Brisbane Central Business District Bicycle User Group

This submission is to voice the views of the CBD BUG on the proposed redevelopment of Victoria Park outlined in BCC's Victoria Park Draft Vision document. Figures 1, 2 and 3 referred to within this submission are provided at the end of this document.

Figure 1

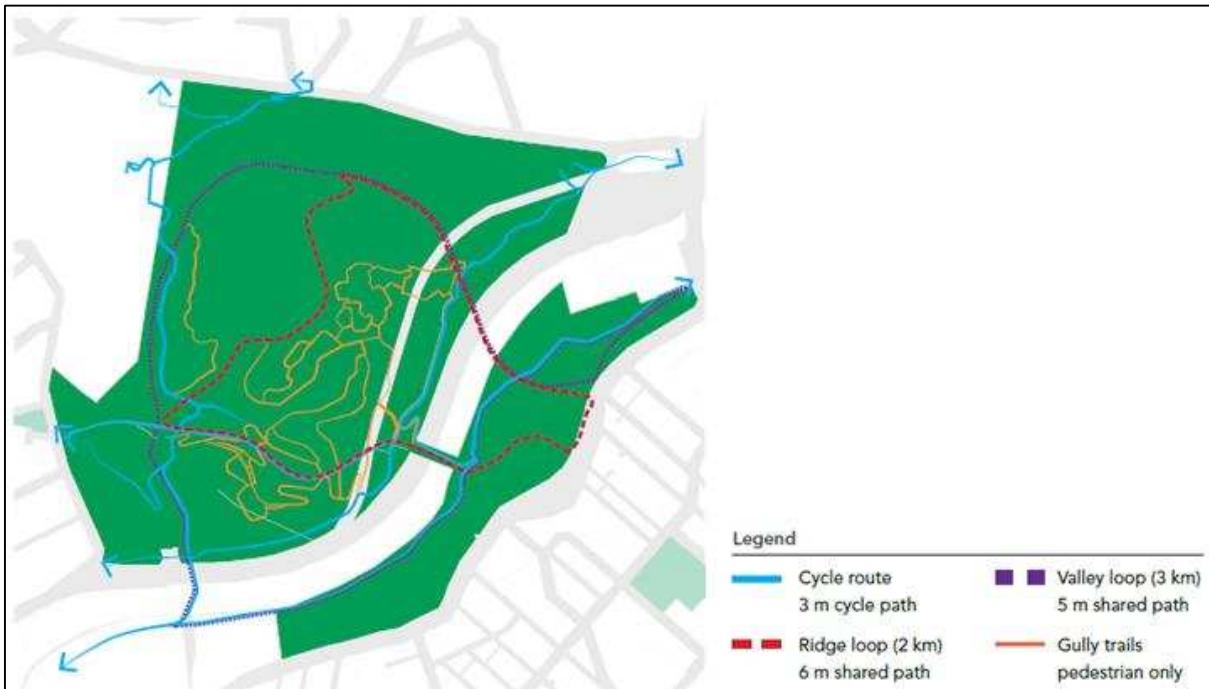
It is pleasing to see the draft plan lists primary corridors "cycle route" as being a "3m cycle path" (Figure 1). We infer from this that the paths are to be dedicated/segregated paths allowing for high volumes ensuring safety and amenity for all. We would suggest 3m should be a bare minimum and 3.5 to 4m would be more suitable to avoid future upgrading works.

Aberleigh Rd is the corridor people cycling from the Enoggera Creek Bikeway and Kedron Brook Road use when accessing the CBD. When looking at the connections map on page 15 (Figure 1) it does not match the Illustrative Concept on pages 29 and 30 (Figure 3). The connections map shows a “3m cycle path” linking to Aberleigh Rd, but the Illustrative Concept does not show this connection. Direct connection to Aberleigh Rd is vital to ensure it reaches its full potential. We hope this inconsistency is simply a drafting mistake.

Figure 3

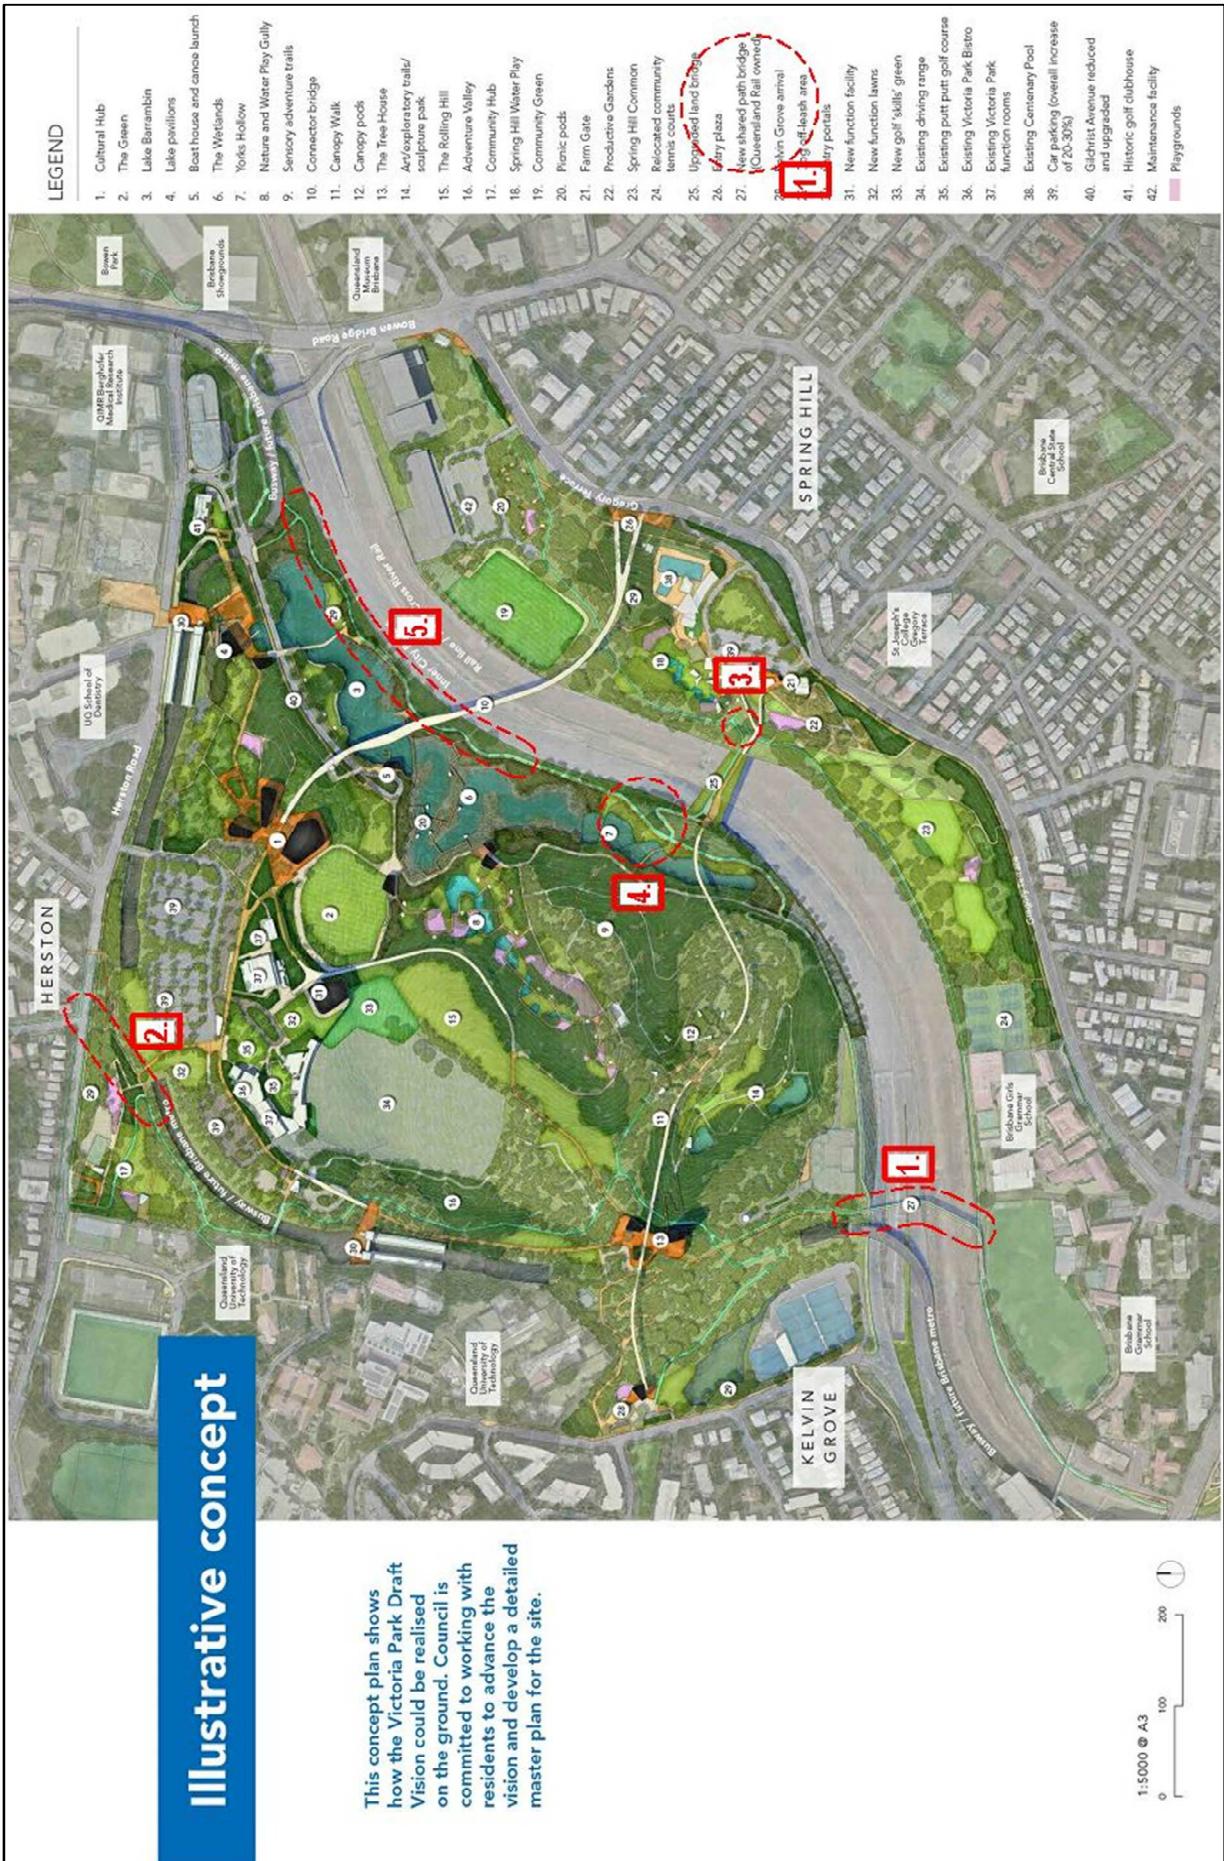
2a. New Bridge (Figure 3)

A new bridge over the Normanby rail yards and the ICB is critical for the North South Corridor to be functional. It is good to see the cycling corridor over this bridge (and linking to the existing NBB) is to be dedicated cycle path, but we are concerned the bridge may not be built. This bridge is the only one with a note placed beside it ("Queensland Rail owned") in the Draft Vision. None of the other proposed bridges have this note placed beside them. We understand the existing bridge is reaching the end of its life and for this reason we have raised the need for to be replaced with an improved structure in our discussions with Cross River Rail.

2b. Linking to Aberleigh Rd (Figure3)

3a. Land Bridge Southern Approach (Figure 3)

The approach to the land bridge has a tight 180-degree turn. While it is assumed this is to gain height after passing under a pedestrian bridge the approach needs to be amended. Tight bends make ascending vertical inclines more difficult due to momentum having to be reduced to negotiate an overly tight bend. Such a bend also increases the potential conflict between people on bicycles traveling in opposing directions

3b. Land Bridge Northern Approach (Figure 3)

The approach to the land bridge has two tight 150-degree turns. While it is assumed this is to gain height the approach has to be amended. It would be preferred that any approach would be as straight as possible. This could be in the form of an embankment or a bridge structure. Tight bends make ascending vertical inclines more difficult due to momentum having to be reduced to negotiate an overly tight bends. Such bends also increase the potential conflict between people on bicycles traveling in opposing directions.

3c. Unnecessary bends (Figure 3)

The realignment of the NBB paralleling the ICB is a welcome improvement that will save travel time for people accessing the suburbs of Albion, Wooloowin and further north. That said, it appears unnecessary bends in the NBB have been added for aesthetic appeal. Such use of bends is advised against in “AustRoads – Part 6A, Pedestrian & Cyclist Paths” where it clearly states - “Sharp curves should not be used to achieve landscaping objectives” (Figure 2)

While we are unable to determine the radii of such bends recent path installations by BCC have been of a radii that contradicted the AustRoads recommended approach.
